<b>Subject:</b> <b>WARNING LIGHT ON WITH DTC P1887:11 - 14 AND/OR NOISE FROM COUPLING UNIT</b>	<b>Bulletin No:</b> 03-004/16
	<b>Last Issued:</b> 09/09/2016

2013-2016 CX-5 AWD vehicles with VINs lower than JM3KE\*\*\*\*\*837718 (produced before July 1, 2016)

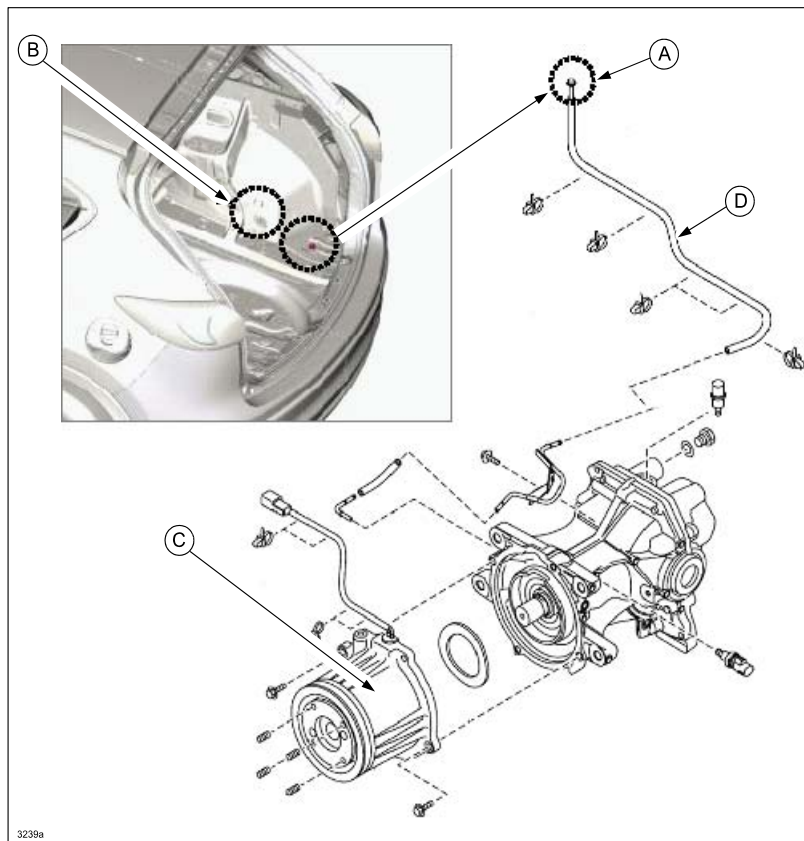
The breather pipe grommet (A), located in the trunk, may be submerged in water that penetrated through the rear ABS wheel-speed sensor harness grommet (B) during a high pressure car wash. The water then enters the coupling unit (C) through the breather pipe (D). This creates rust inside the coupling unit, which causes internal wiring harness damage, setting the DTC and/or the coupling unit noise due to increased rotational resistance.

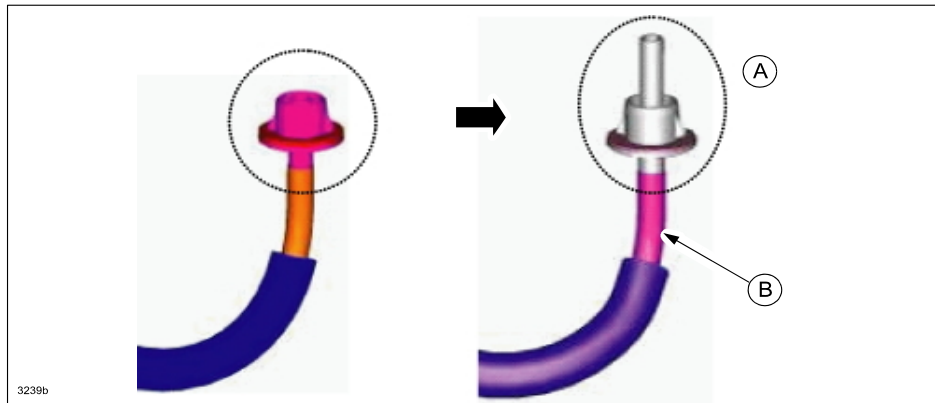
The configuration of the breather pipe grommet (A) has been changed to prevent water from entering the breather pipe (B), even if water accumulates in the trunk.
